UNITED STATES
DEPARTMENT OF THE INTERIOR
BUREAU OF LAND MANAGEMENTNM OIL CONSERVATION
ARTESIA DISTRICTFORM APPROVED
OMB NO. 1004-0135
Expires: July 31, 2010**SUNDRY NOTICES AND REPORTS ON WELLS**
*Do not use this form for proposals to drill or to re-enter an abandoned well. Use form 3160-3 (APD) for such proposals.*5. Lease Serial No.
NMLC065873A

7. If Unit or CA/Agreement, Name and/or No.
891000326N8. Well Name and No.
COBB FEDERAL 19. API Well No.
30-015-05829-00-S110. Field and Pool, or Exploratory
BRUSHY CANYON11. County or Parish, and State
EDDY COUNTY, NM**SUBMIT IN TRIPLICATE - Other instructions on reverse side.**

BOPCO, LP respectfully submits this sundry notice of intent to plug & abandon the referenced well.
The plugging procedure is as follows:

** BLM REVISED ** BLM REVISED ** BLM REVISED ** BLM REVISED ** BLM REVISED **

WBD - Vertical - Proposed

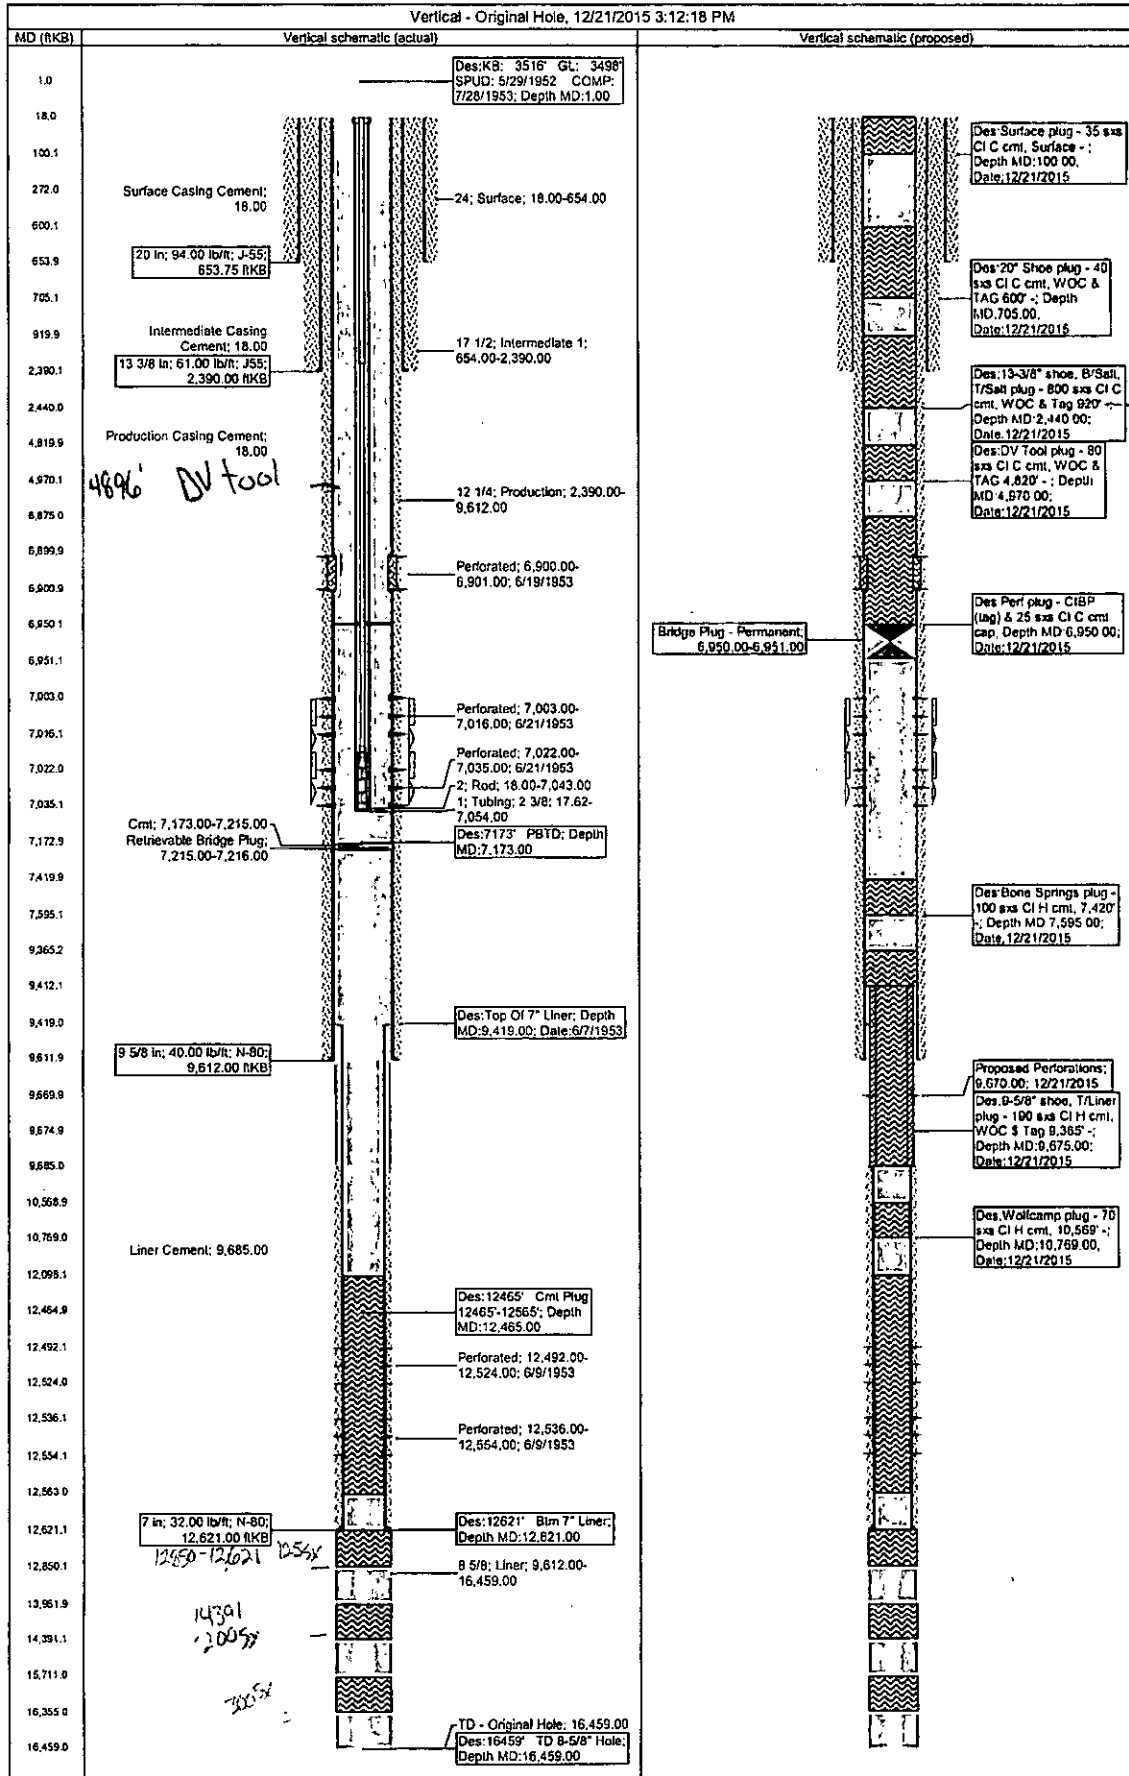
10. PUH to 2,440, spot 800 sxs CI C cmt from 2,440'-⁸²²920'. WOC & TAG. (13-3/8" shoe, B/Salt, T/Salt @ 872' plug)

13. ND BOP and cut off wellhead 5? below surface. Set P&A marker. @

below ground level marker required. See COR
